Access Compliance Report

# Public Rights-of-Way
(Curb Ramps)

Intersection ID: 10503	Main Street: N_GRAHAM_ST	Cross Street: PLYMOUTH_AV	Location:	SE
ADA ID: E4CF3EB5F5CA	Ramp Type: PerpDiag	Initial Pass/Fail: Fail	Overall Compliance: No	Severity Score: 12.5

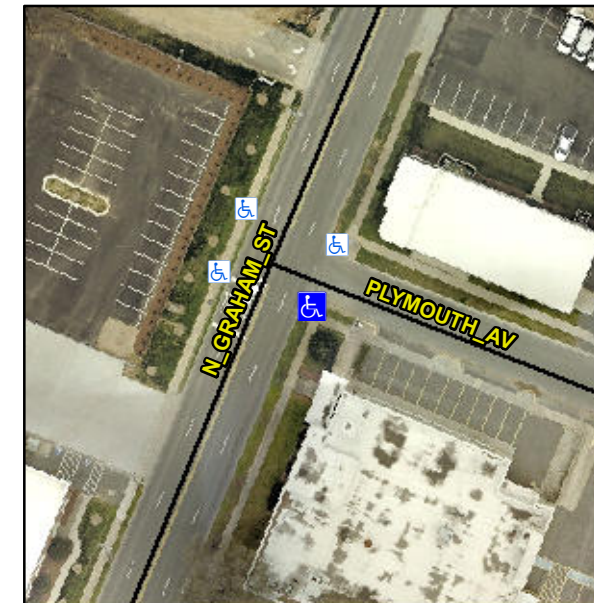
Remove & Replace Curb Ramp With Two New Directional Ramps or Equivalent.

R304.2.2

Compliance	Description	Data	Compliance	Description	Data
N/A	Ramp Length (in)	74.0	No	Ramp Slope (%)	9.3
Yes	Ramp Width (in)	51.0	Yes	Ramp XSlope (%)	0.5
N/A	Flare Type LT	N/A	N/A	Flare Type RT	N/A
N/A	Flare Slope LT (%)	N/A	N/A	Flare Slope RT (%)	N/A
N/A	Flare Traversable LT?	N/A	N/A	Flare Traversable RT?	N/A
N/A	Landing Length (in)	N/A	N/A	DWS Provided?	N/A
N/A	Landing Width (in)	N/A	N/A	DWS Contrast?	N/A
N/A	Landing Slope (%)	N/A	N/A	DWS Length (in)	N/A
N/A	Landing X Slope (%)	N/A	N/A	DWS Full Width?	N/A
N/A	Landing Curb? (Y/N)	N/A	N/A	DWS Offset (in)	N/A
N/A	Shared Landing?	N/A			
N/A	Gutter Ponding?	Yes	N/A	Gutter Slope (%)	N/A
N/A	Gutter Lip Ht (in)	N/A	N/A	Gutter X Slope (%)	N/A
N/A	Painted X Walk1?	No	N/A	Painted X Walk2?	No
	X Walk 1 Direction	To NE		X Walk 2 Direction	To NW
N/A	X Walk 1 Width (in)	N/A	N/A	X Walk 2 Width (in)	N/A
	X Walk 1 Slope (%)	1.2		X Walk 2 Slope (%)	4.6
	X Walk 1 X Slope (%)	1.7		X Walk 2 X Slope (%)	0.6
